KCK COMMUNITY EDUCATION, HEALTH & WELLNESS CENTER

ADDENDUM #1

PGAV PROJECT #53664-00

April 15, 2024

A001

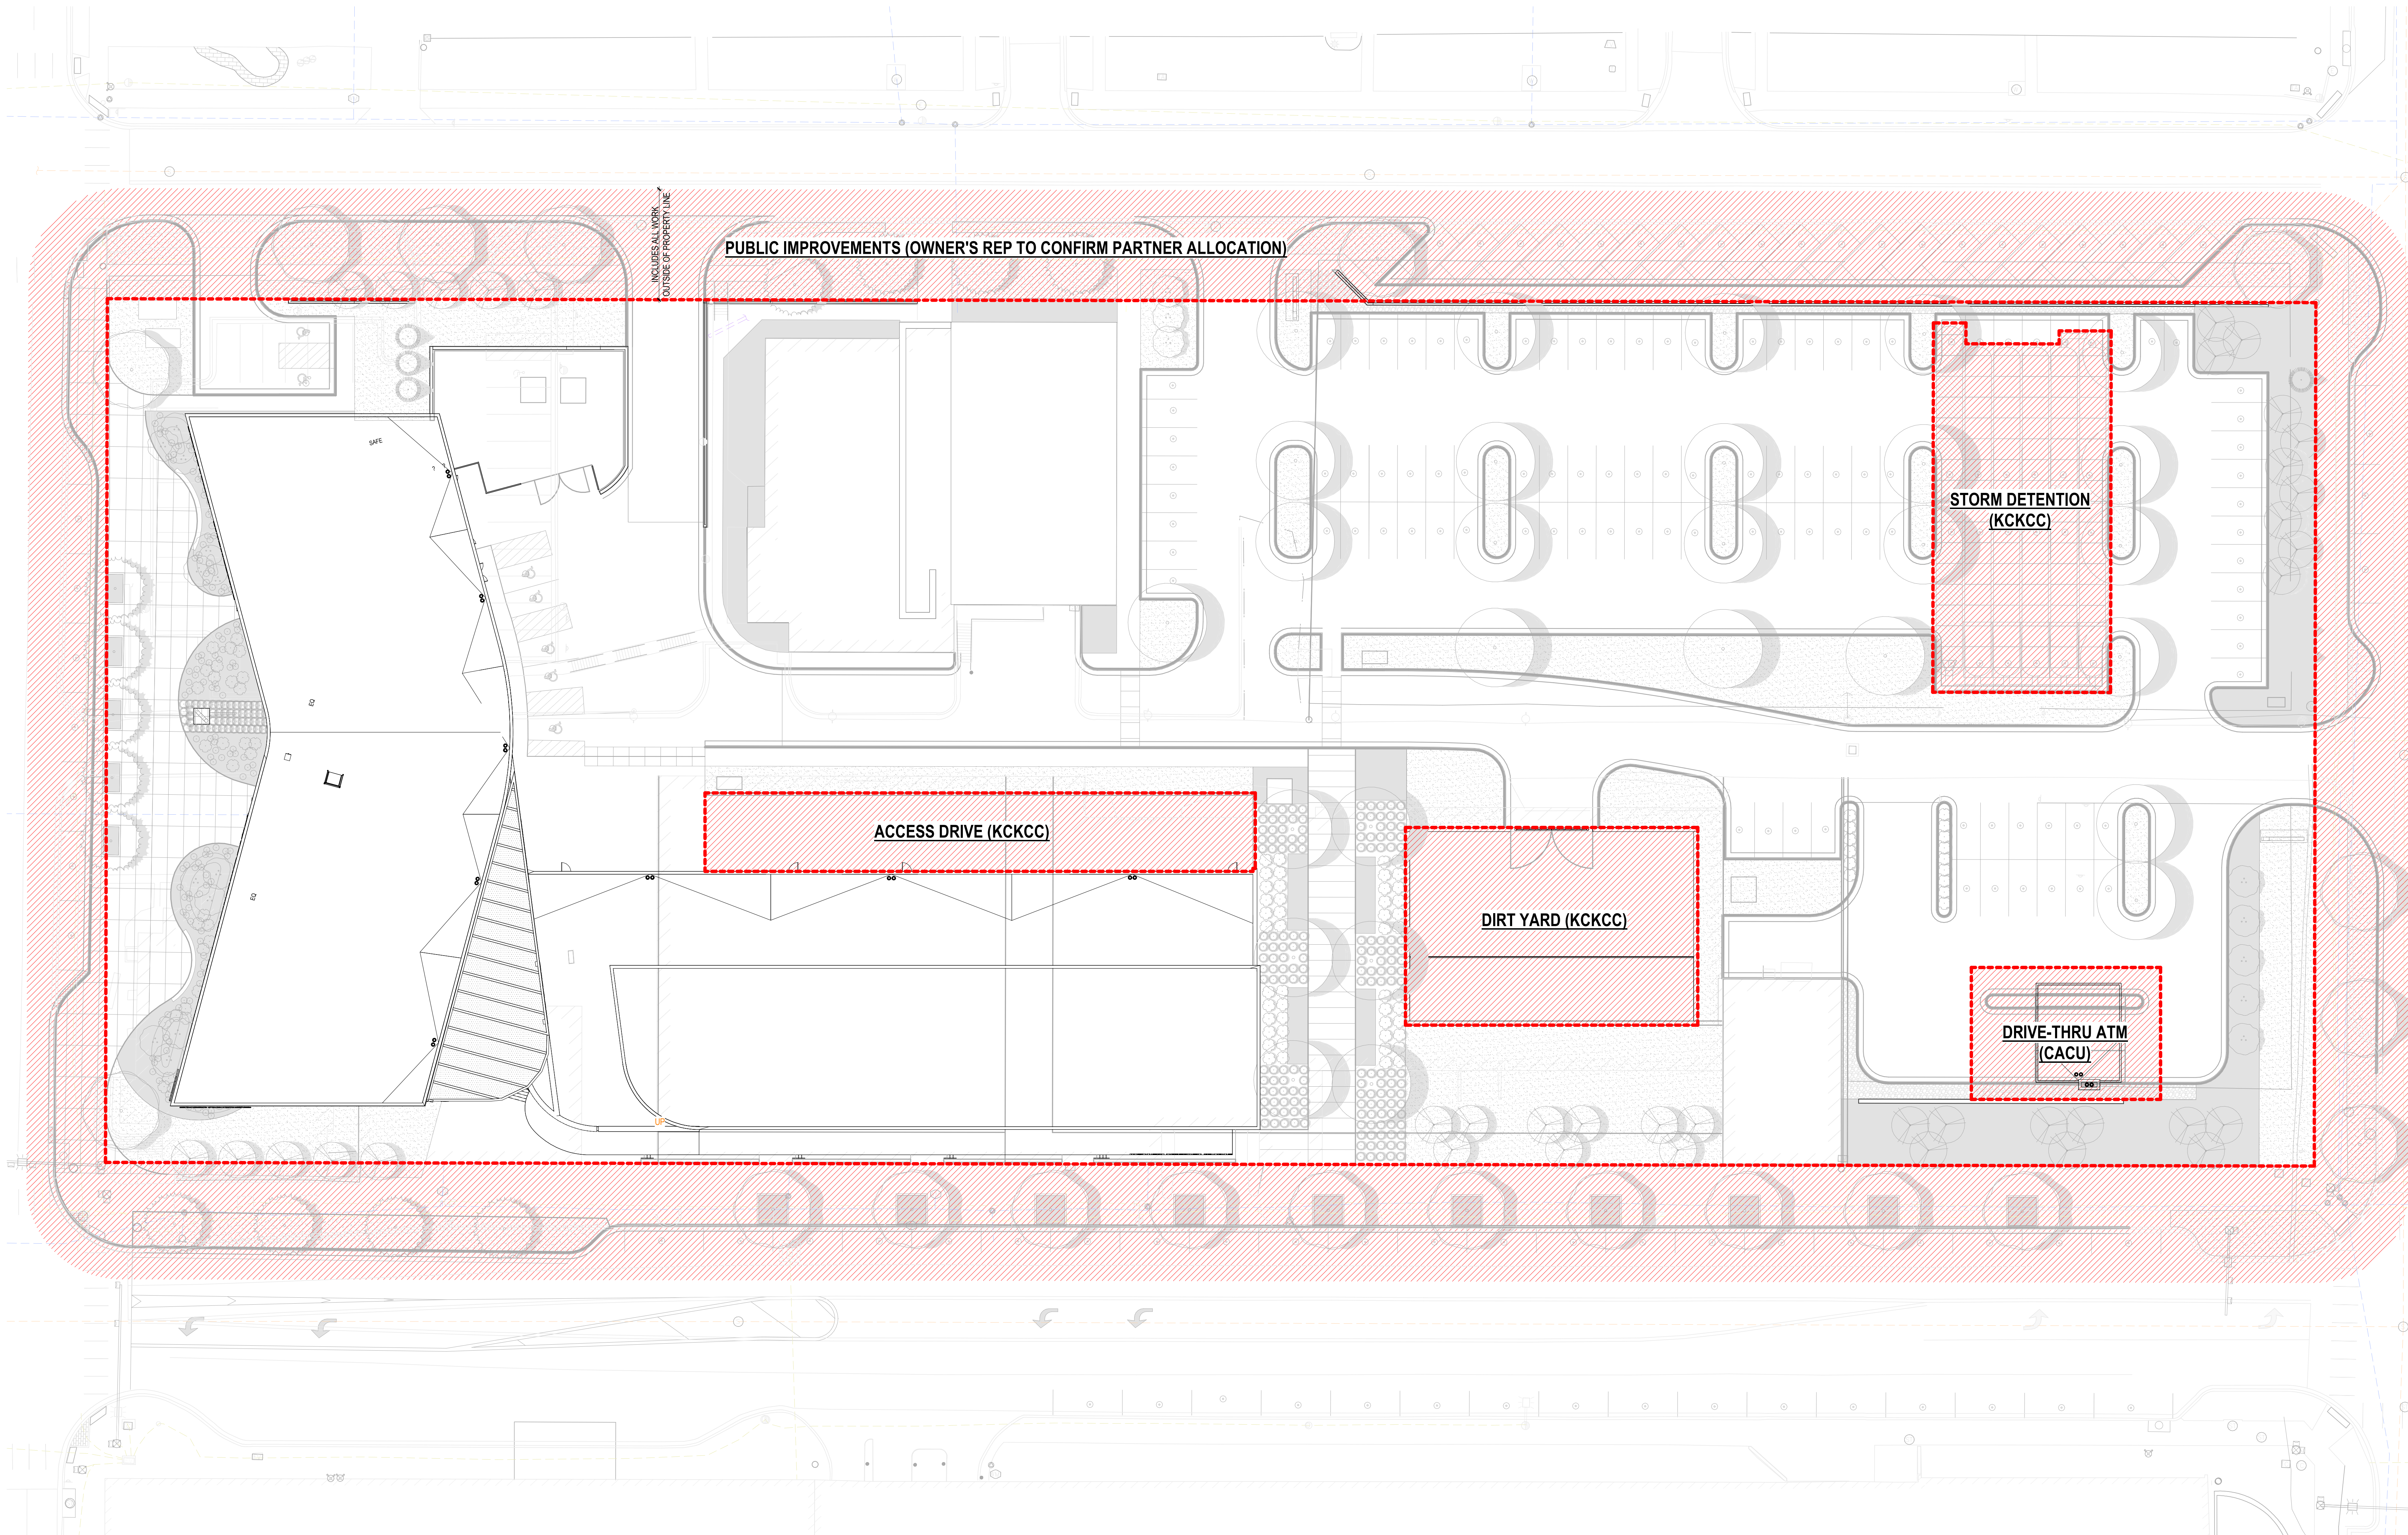
1. Refer to the attached revised sheet with revisions dated 4/15/2024:
 - a. Clarified scope of work divisions related to partner cost allocations.

C110

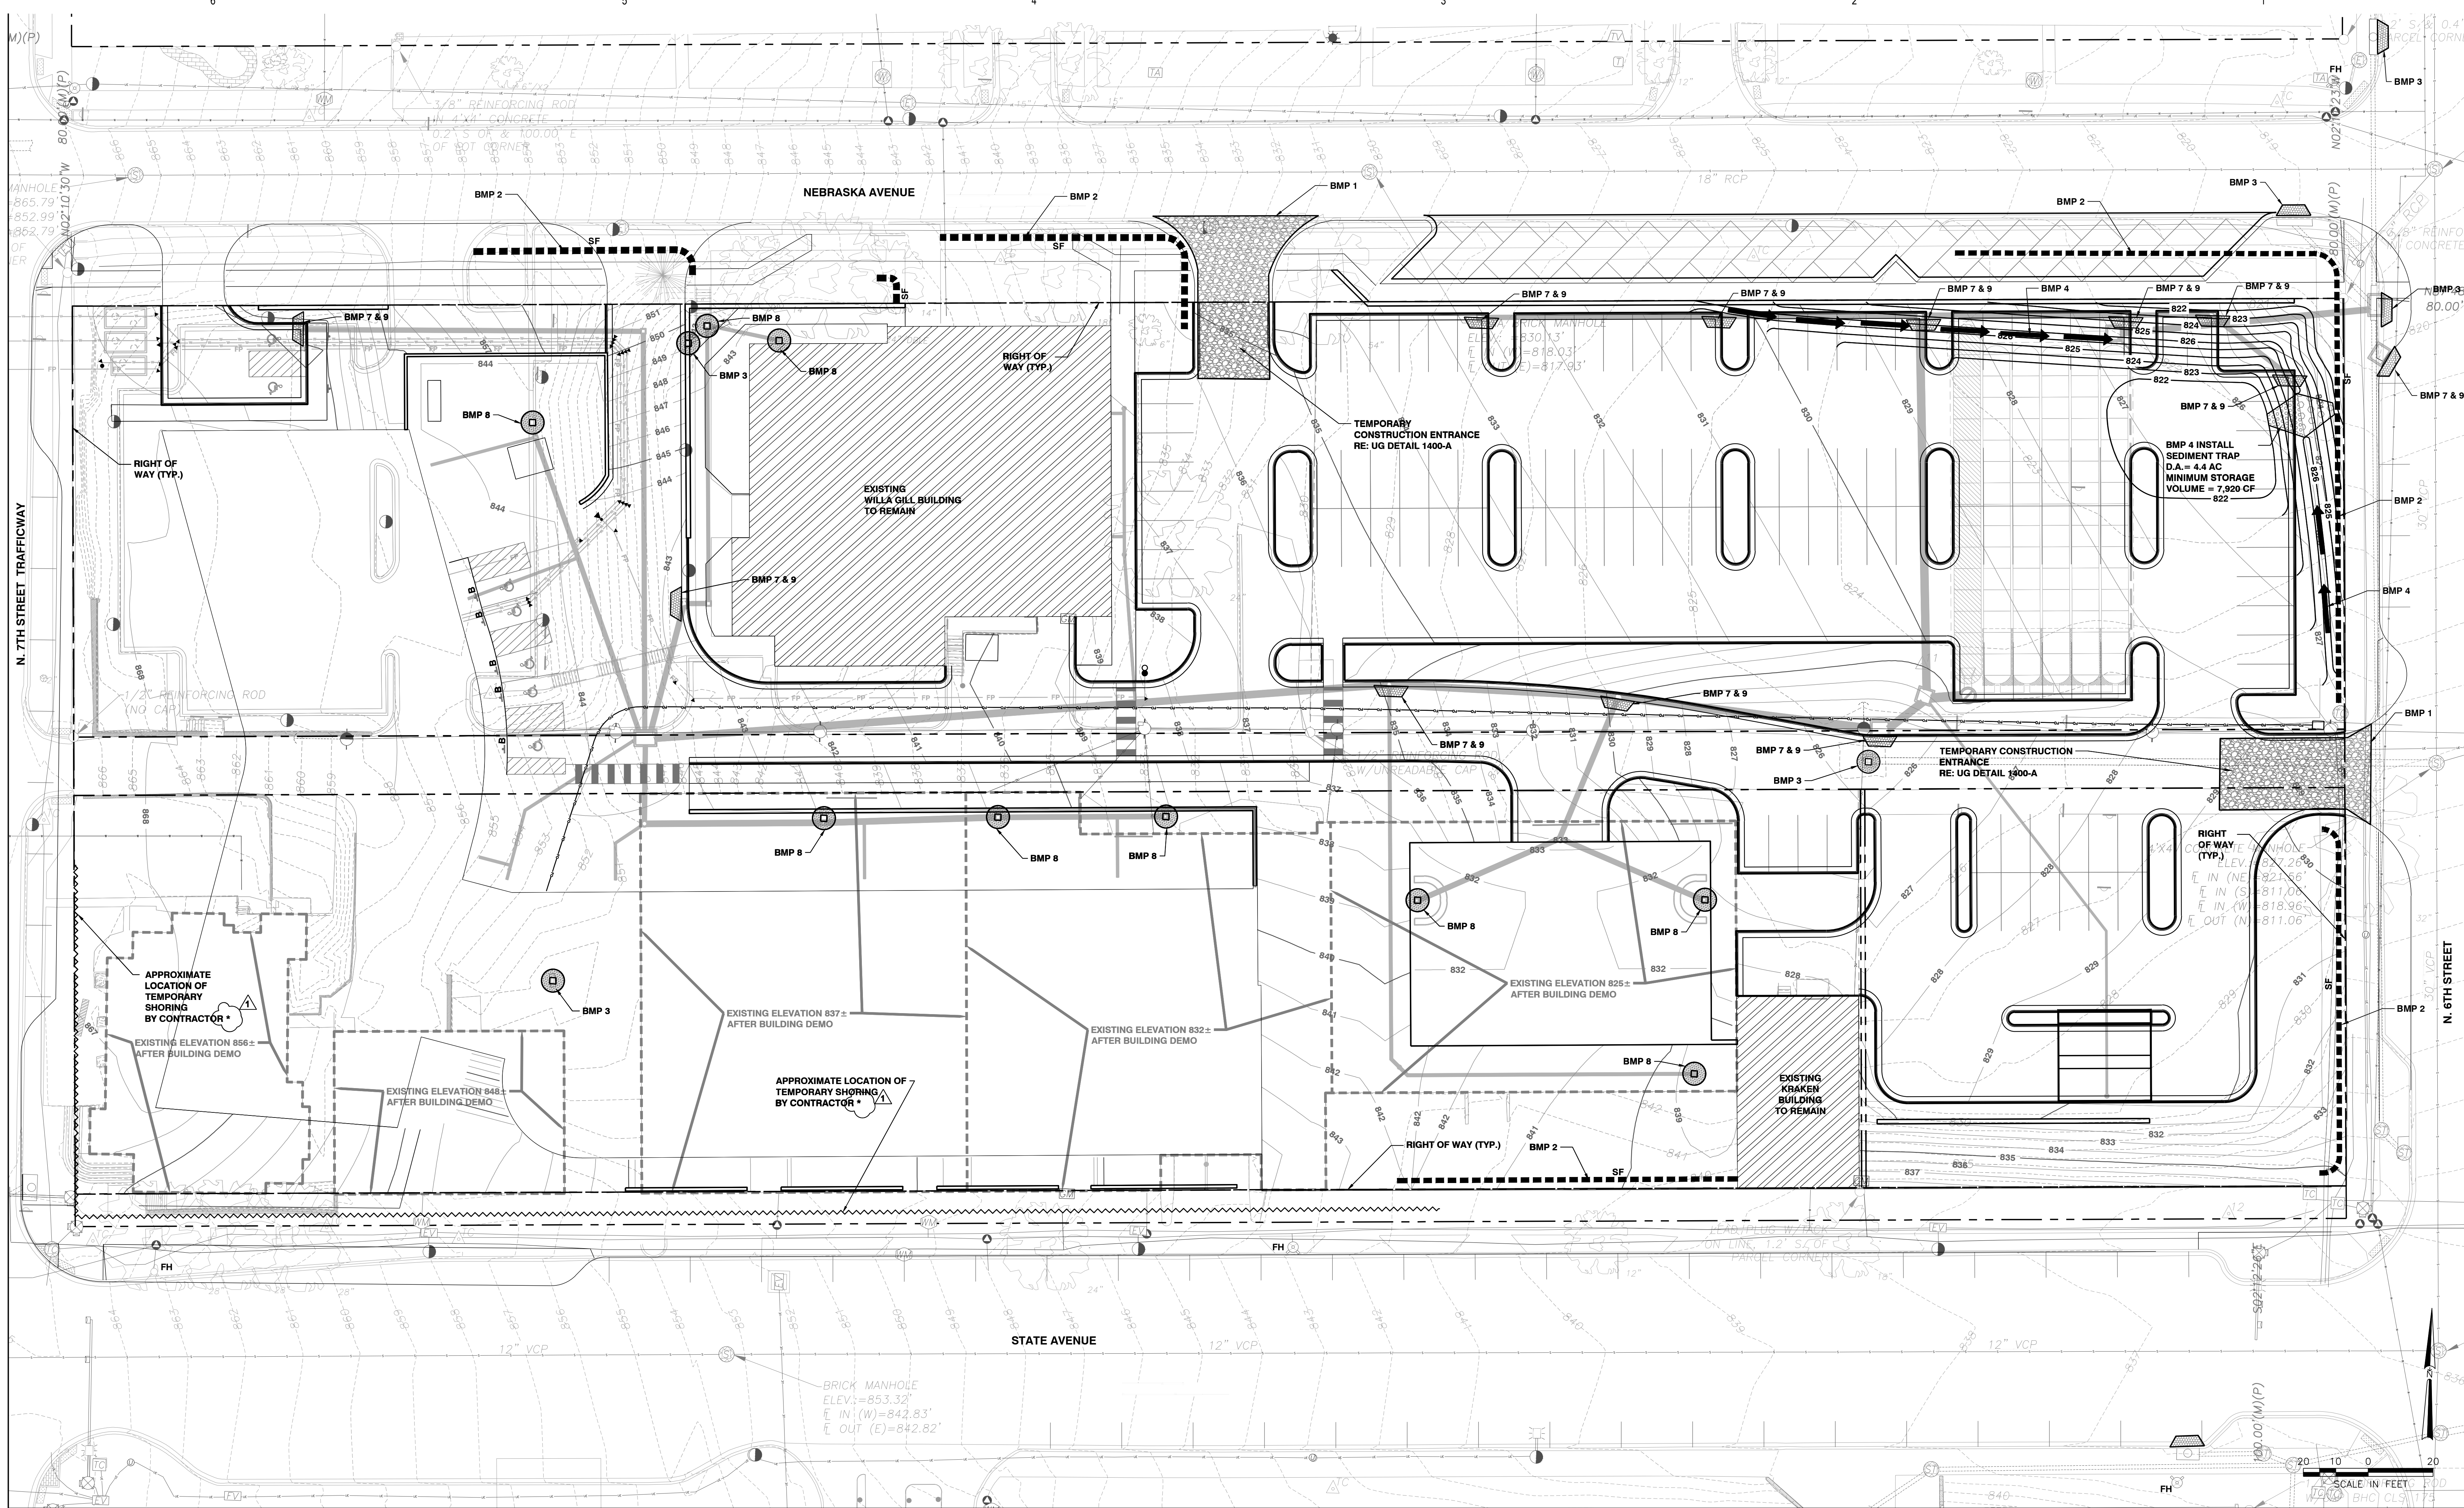
1. Refer to the attached revised sheet with revisions dated 4/15/2024:
 - a. Added clarification for temporary shoring.

1. C110 indicates "approximate shoring location of temporary shoring by contractor". Plans indicate 530 LF. Current anticipated shoring extents only provide shoring for approximately 200 LF along State Ave in addition to (10) buttresses that are installed. Please confirm these notes are not intended for actual shoring requirements/locations to be installed.

ANSWER: Contractor is responsible for shoring the excavation and protection of existing utilities. Contractor is also responsible to protect the portions of the right of way that are to remain. Extent of shoring is the responsibility of the contractor. The note was not intended to be a requirement.

C201

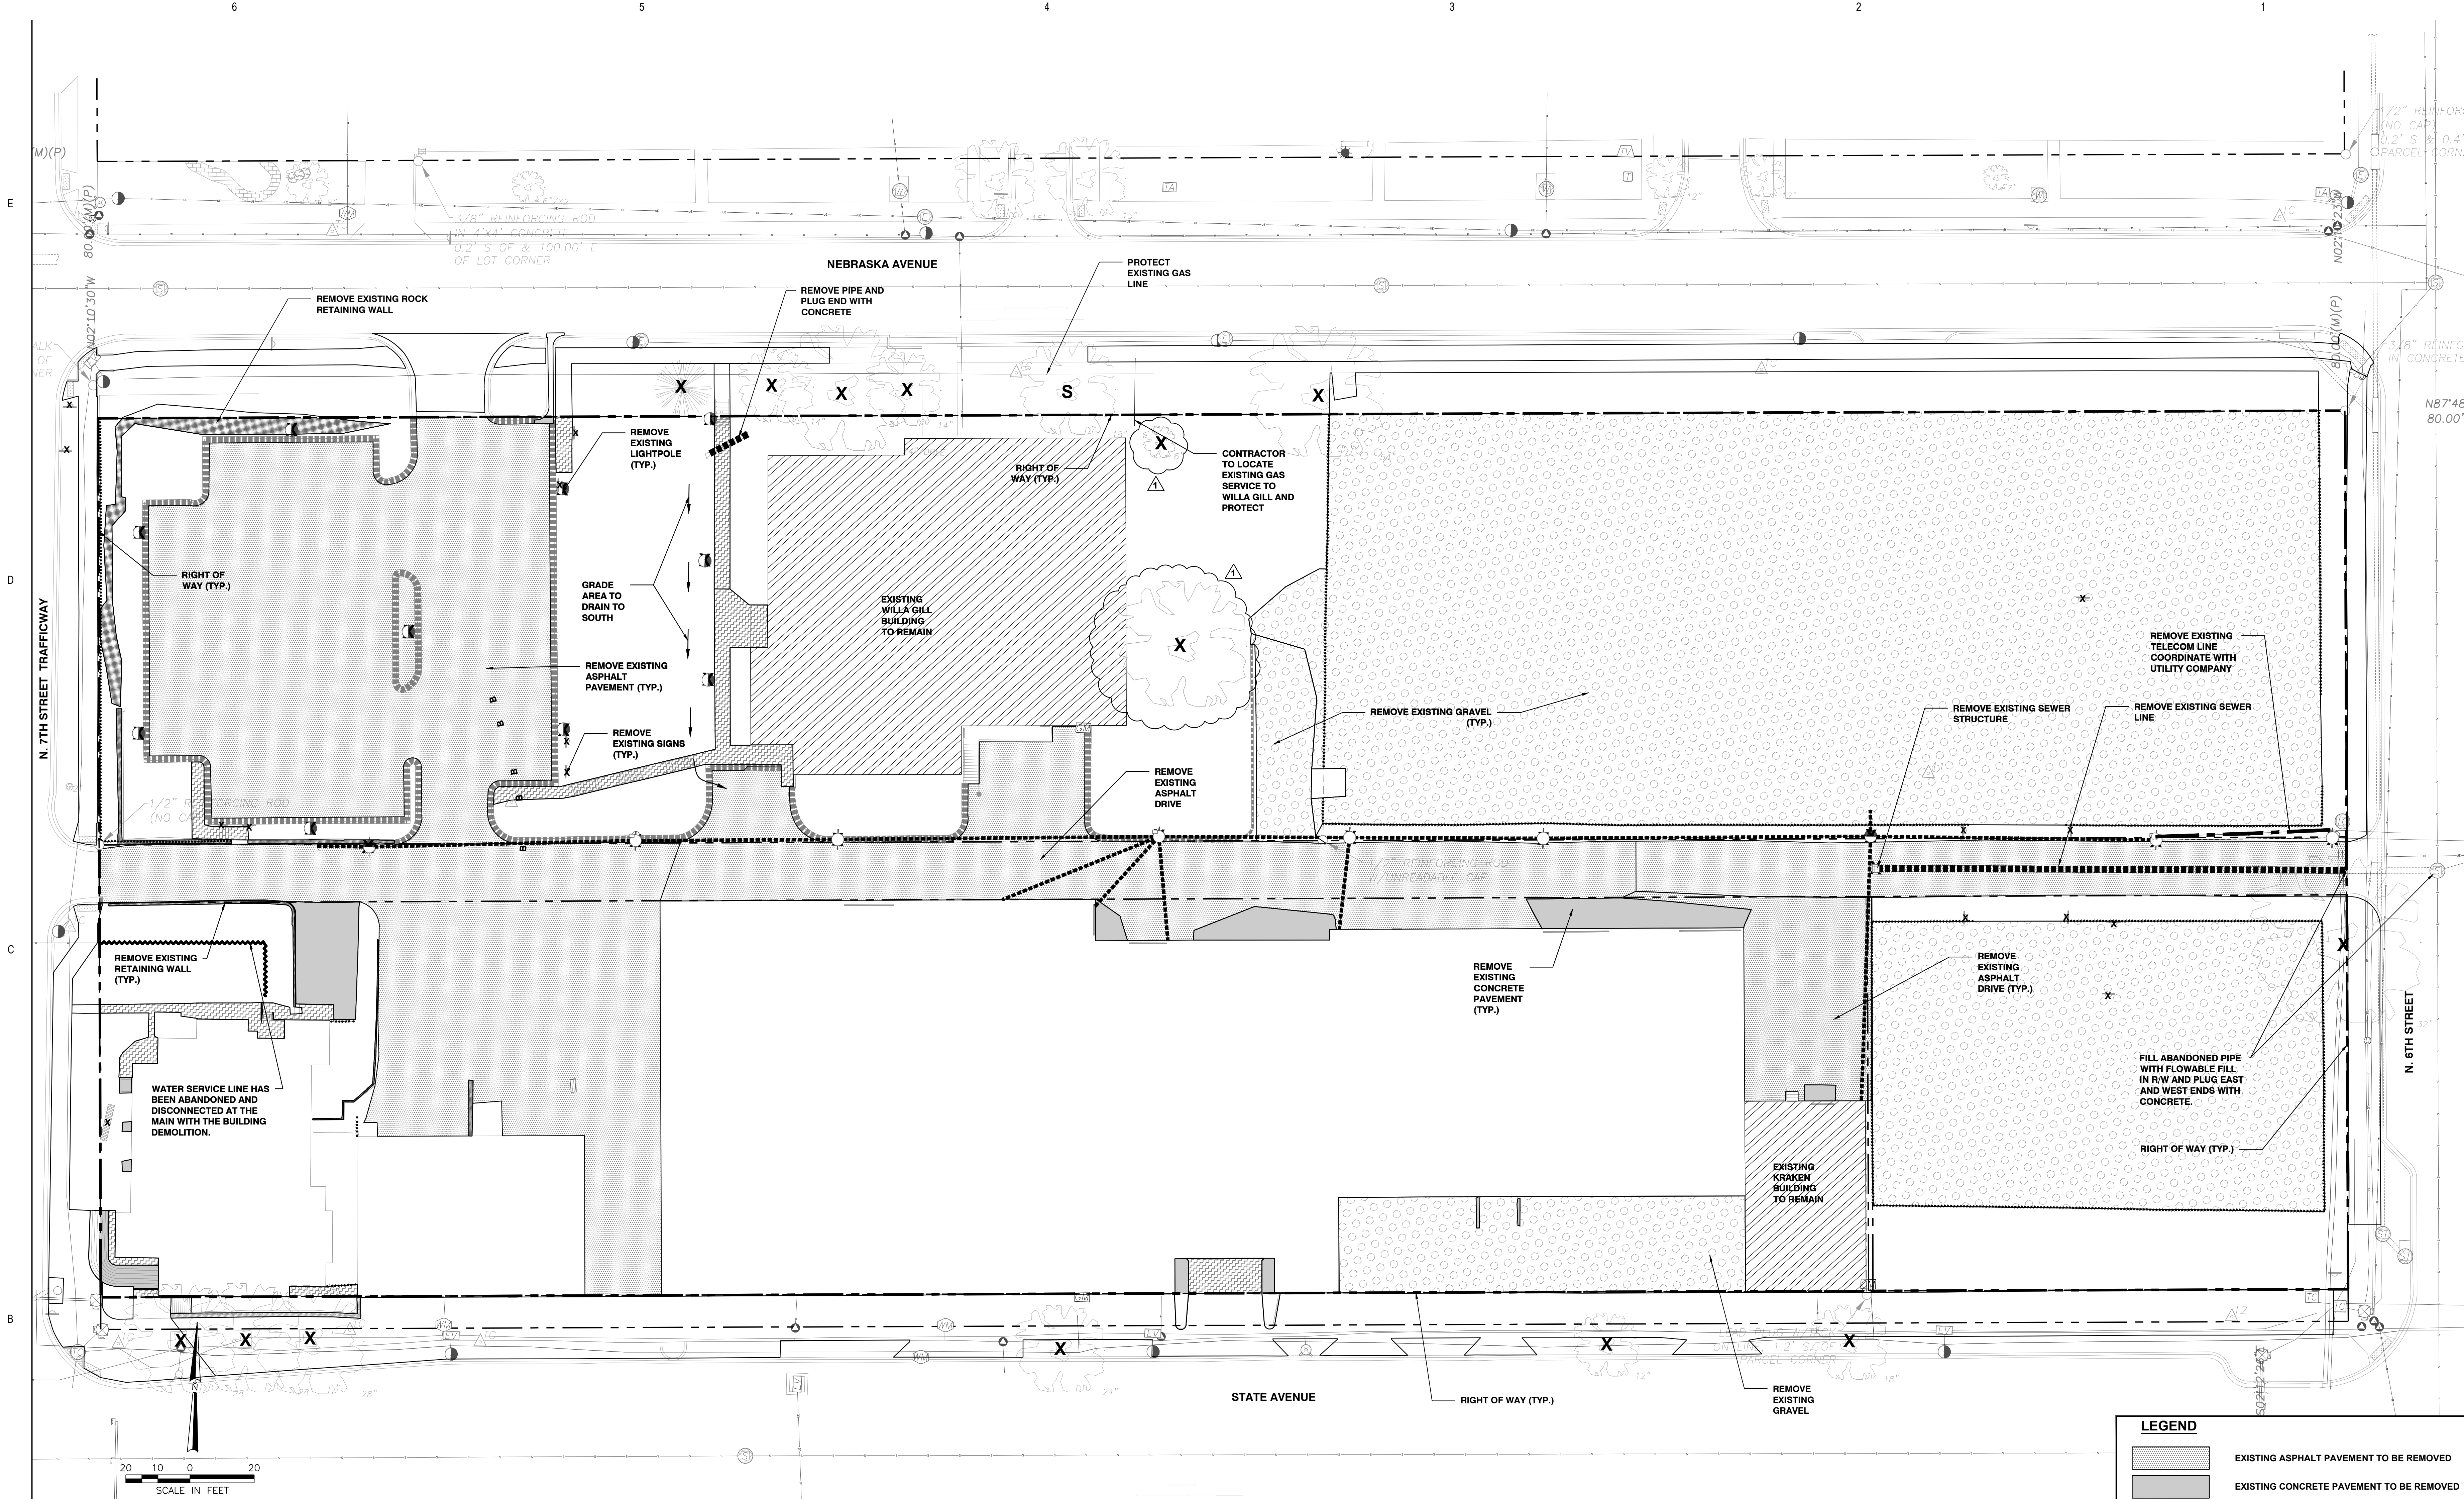
1. Refer to the attached revised sheet with revisions dated 4/15/2024:
 - a. Added tree locations and removals.

- 9. C201 Demolition Plan: Existing trees are not noted to be removed, verify if these will all be removed and provide mark-up on plans.**

ANSWER: Yes, all trees in conflict with new construction are to be removed. A revised plan will be issued.
